Access Compliance Report

Public Rights-of-Way

(Curb Ramps)

Intersection ID: 29979		Main Street: REIGATE_RD		Cross Street: ALBANS_LN		Location: NE			
ADA ID: E5393775F5D3		Ramp Type: PerpDiag		Initial Pass/Fail: Fail		Overall Compliance: No		Severity Score: 10	
Codes/Mitigation Info/Possible Solution				Field Measurements/Component Compliance

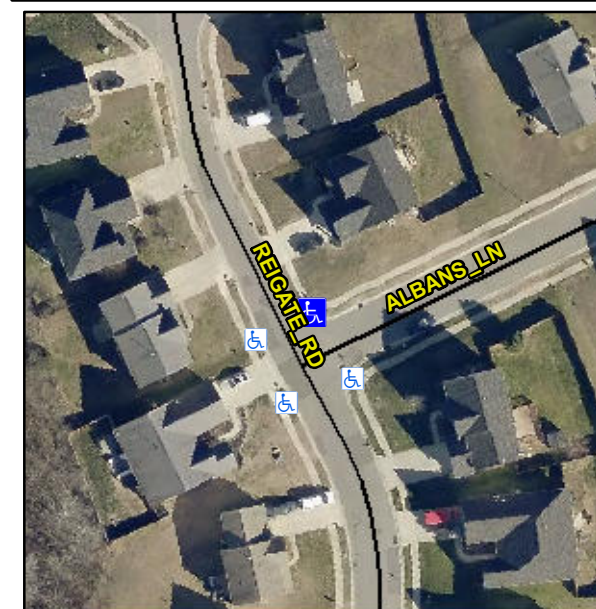
Not Found, R304.5.1, R304.5.3

Compliance	Description	Data	Compliance	Description	Data
N/A	Ramp Length (in)	46.0	Yes	Ramp Slope (%)	5.2
No	Ramp Width (in)	40.5	No	Ramp XSlope (%)	3.6
N/A	Flare Type LT	N/A	N/A	Flare Type RT	N/A
N/A	Flare Slope LT (%)	N/A	N/A	Flare Slope RT (%)	N/A
N/A	Flare Traversable LT?	N/A	N/A	Flare Traversable RT?	N/A
N/A	Landing Length (in)	N/A	N/A	DWS Provided?	N/A
N/A	Landing Width (in)	N/A	N/A	DWS Contrast?	N/A
N/A	Landing Slope (%)	N/A	N/A	DWS Length (in)	N/A
N/A	Landing X Slope (%)	N/A	N/A	DWS Full Width?	N/A
N/A	Landing Curb? (Y/N)	N/A	N/A	DWS Offset (in)	N/A
N/A	Shared Landing?	N/A			
N/A	Gutter Ponding?	N/A	N/A	Gutter Slope (%)	N/A
N/A	Gutter Lip Ht (in)	N/A	N/A	Gutter X Slope (%)	N/A
N/A	Painted X Walk1?	No	N/A	Painted X Walk2?	No
	X Walk 1 Direction	To W		X Walk 2 Direction	To S
N/A	X Walk 1 Width (in)	N/A	N/A	X Walk 2 Width (in)	N/A
	X Walk 1 Slope (%)	0.0		X Walk 2 Slope (%)	1.5
	X Walk 1 X Slope (%)	1.9		X Walk 2 X Slope (%)	0.3

Remove & Replace Curb Ramp With Two New Directional Ramps or Equivalent.
